**EXAMPLE
REPORT**

Thermographic Survey

Sample Report 4

Balcony door

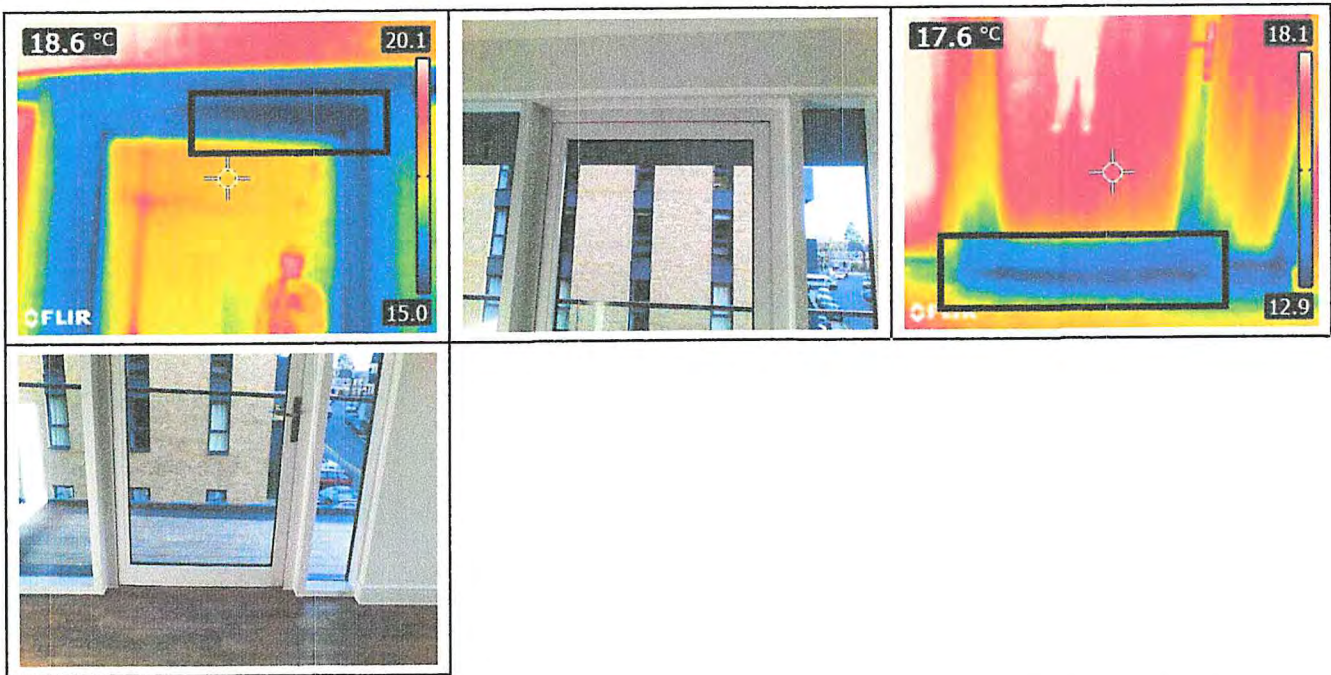
The balcony doors within the living room are showing two notable issues allowing cold air to penetrate from the external leaf. Firstly, the head of the door to the frame is showing a noticeable gap approximately 7mm wide. This gap is allowing a noticeable amount of cold air penetration due to the seal between the door and frame being incomplete. Secondly, the foot of the door along the threshold is also showing penetration, meaning the seal is inadequate between the door and threshold. This issue combined with issue 1 would suggest the door has dropped from it's hinge.

Garage

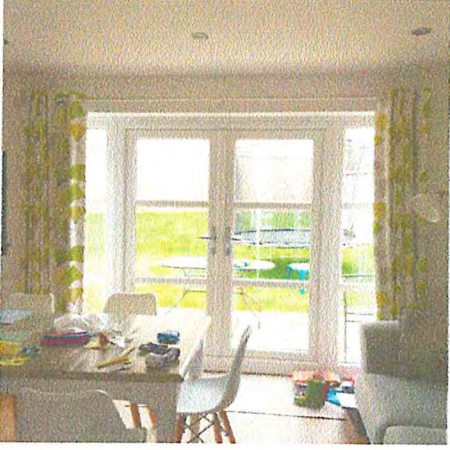
<p>Unacceptable finish to pointing to elevation <input type="checkbox"/></p> <p>.....</p> <p>Inadequate dressing to tanked wall end <input type="checkbox"/></p> <p>.....</p> <p>Remediation to RWP gulley <input type="checkbox"/></p>
	 	<p>Inadequate finish to pointing to elevation <input type="checkbox"/></p> <p>.....</p> <p>Excessive gap to soffit box end - potential infestation (check opposite side) <input type="checkbox"/></p>
	 	<p>Pattress for electrical components to right elevation not secured correctly <input type="checkbox"/></p> <p>.....</p> <p>Pattress for electrical components to rear elevation not secured correctly <input type="checkbox"/></p>

Kitchen

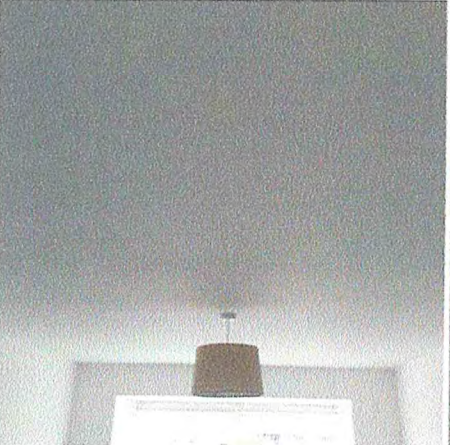
<p>Inconsistent finish to decoration to window reveals</p>	<input type="checkbox"/>
		<p>Slight damage to glazing bead to centre fixed unit</p>	<input type="checkbox"/>
		<p>General marks and residue to window frame perimeters</p>	<input type="checkbox"/>
		<p>Sink base unit doors misaligned</p>	<input type="checkbox"/>
		<p>Inconsistent finish to mastic seal to window frame perimeters</p>	<input type="checkbox"/>
		<p>Inconsistent finish to decoration to window reveals</p>	<input type="checkbox"/>
